CITY OF HOOD RIVER ENGINEERING DEPARTMENT COMMENTS

Site Address: 1419 Sherman Ave.
Owner Name: Sherman Ave. Holdings, LLC
Legal Description: 03N10E35AA04900
Subject: Site Plan Review – Request for Comments
Project #: 2020-03

Based on the preliminary civil engineering plans dated 4/30/20, the Public Works and Engineering Department have the following items to address:

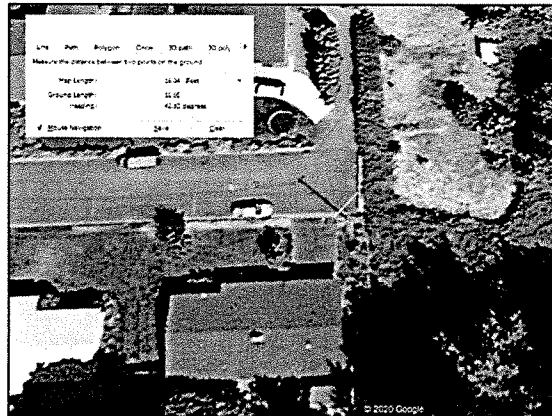
- **ADA Parking Spaces:** Confirm compliance with requirements for ADA accessible parking spaces. ORS 447.233 (which includes requirements for ADA accessible parking spaces) suggests a parking lot with 39 spaces should have two ADA spaces, including one that is van accessible. Applicant proposes one ADA parking space.
- **Compliance with Driveway Access Standards:** Applicant’s Transportation Analysis Letter (TAL) indicates that the driveway spacing between this project and Adams Creek Place is in excess of the 22’, thereby satisfies the Access Spacing Standards in HRMC 17.20.030.B.2. Applicant

TAL appear to ignore the driveway on the south side at Eugene St. The driveway for that single family residence leads into the garage) is very close to and parallels Applicant’s western property line (alongside the proposed parking lot). This existing driveway should be on the Existing Conditions map (Sheet C-6).

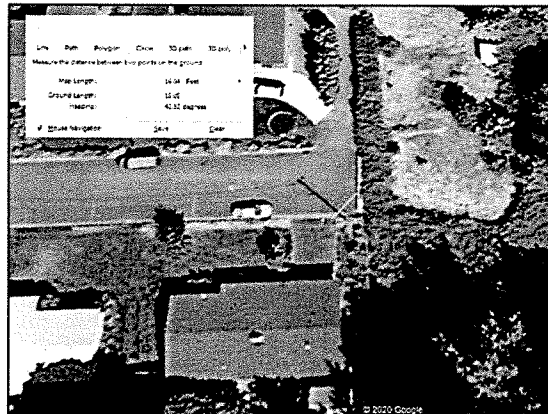
- **ADA Parking Spaces:** Confirm compliance with requirements for ADA accessible parking spaces. ORS 447.233 (which includes requirements for ADA accessible parking spaces) suggests a parking lot with 39 spaces should have two ADA spaces, including one that is van accessible. Applicant proposes one ADA parking space.

- **Compliance with Driveway Access Standards:** Applicant’s Transportation Analysis Letter (TAL) indicates that the driveway spacing between this project and Adams Creek Place is in excess of the 22’, thereby satisfies the Access Spacing Standards in HRMC 17.20.030.B.2. Applicant TAL appear to ignore the driveway on the south side at Eugene St. The driveway for that single family residence leads into the garage) is very close to and parallels Applicant’s western property line (alongside the proposed parking lot). This existing driveway should be on the Existing Conditions map (Sheet C-6).
